RE: Answers to Your Questions  
Application for Administrative Approval of Unorthodox Location  
M & G Drilling Company's Schlosser 34 #102s  
1630' FSL and 495' FWL  
Unit L, Section 34, T28N, R11W  
San Juan County, New Mexico  
Basin Fruitland Coal

Thank you for your questions on our NSL application. I hope the following will help clarify M & G Drilling Company's reasons for an NSL.

SCHLOSSER #97 PC N 34 28 11

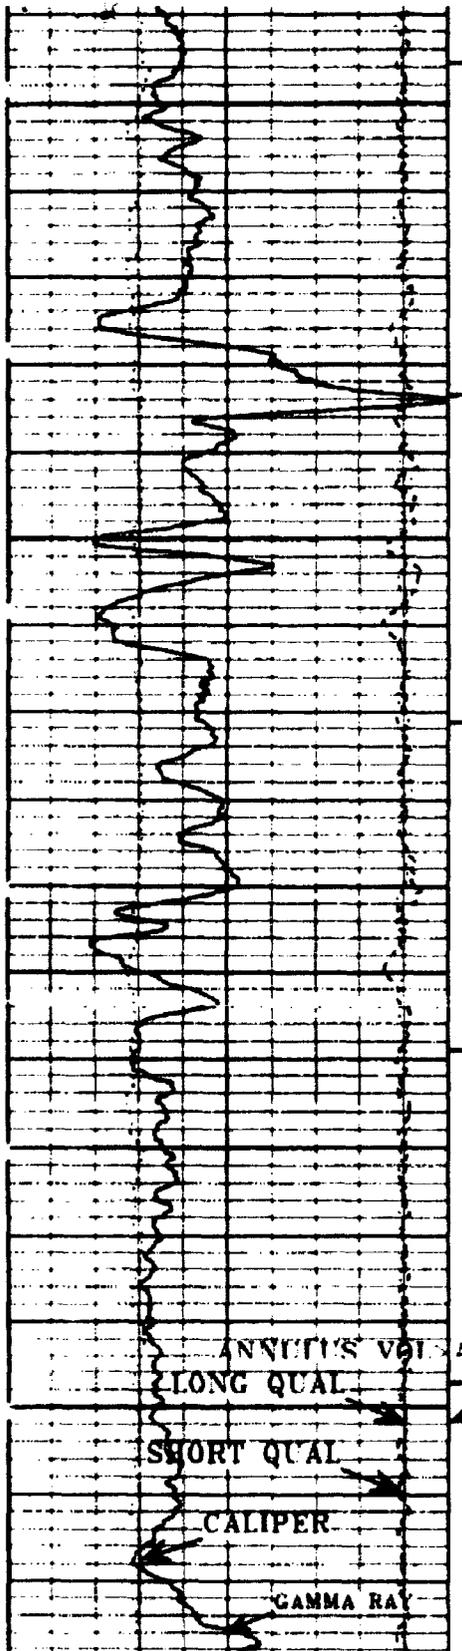
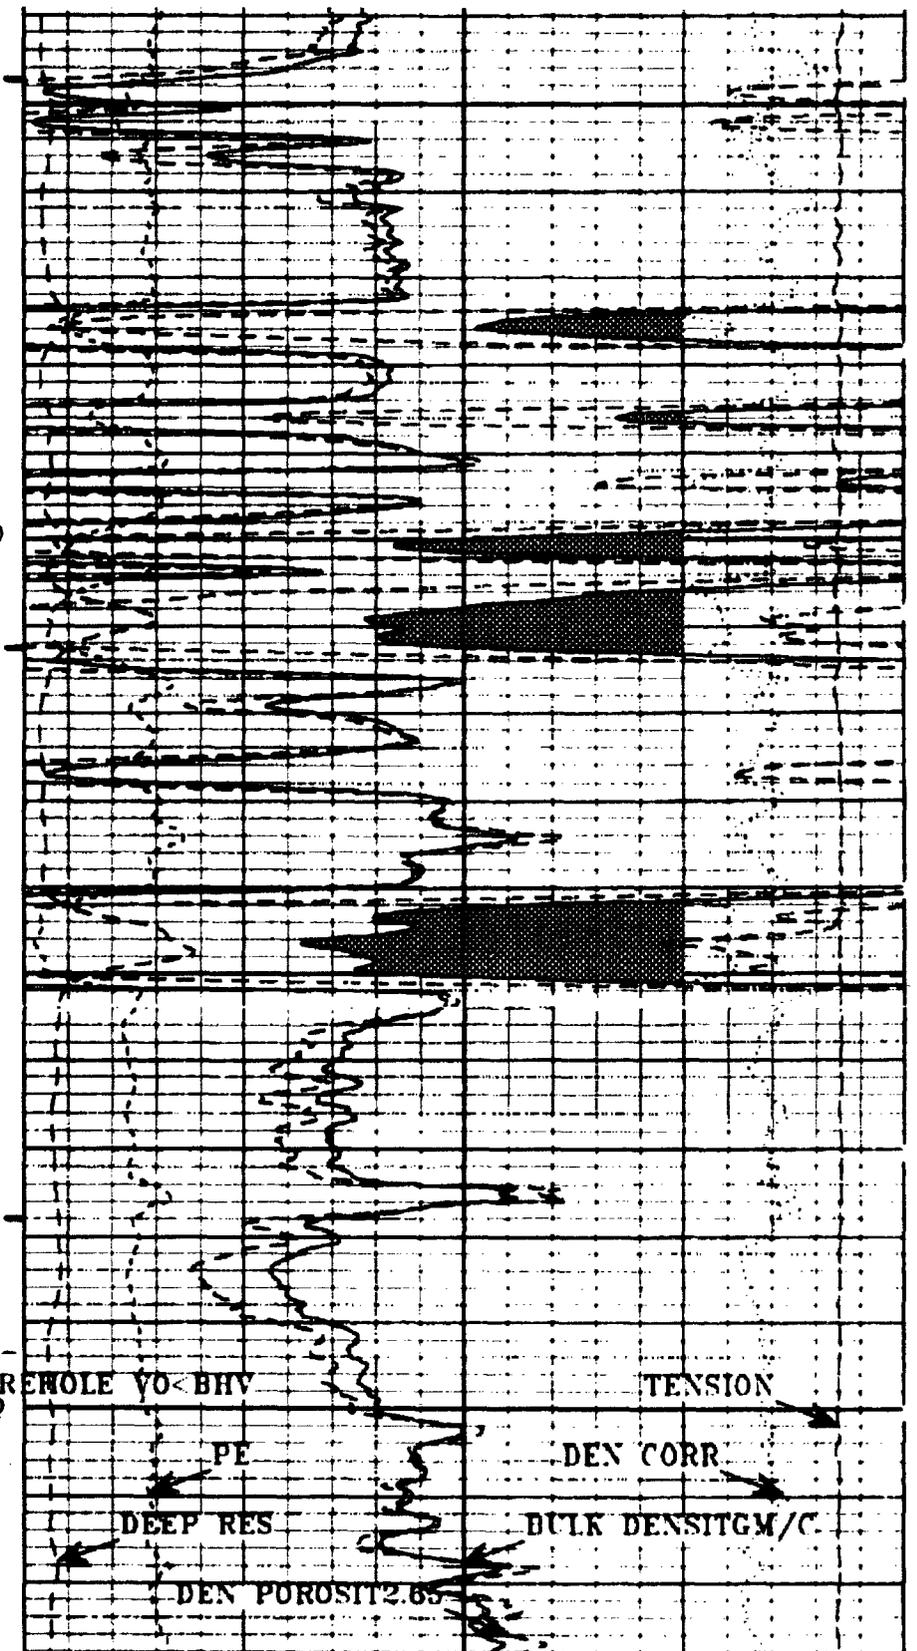
The proven method of completing the Fruitland Coal in this area of San Juan Basin is a large foam frac. The attached log from the Schlosser #97 PC (N 34 28 11) indicates only 3 or 4 feet between the bottom of the basal coal and the top of the Pictured Cliffs sand. It is easy to see how a foam frac, which has a height of at least 30 feet above and below the perforated interval could frac into the Pictured Cliffs.

BASE OF CORAL ~1852'

TOP OF PC ~1855'
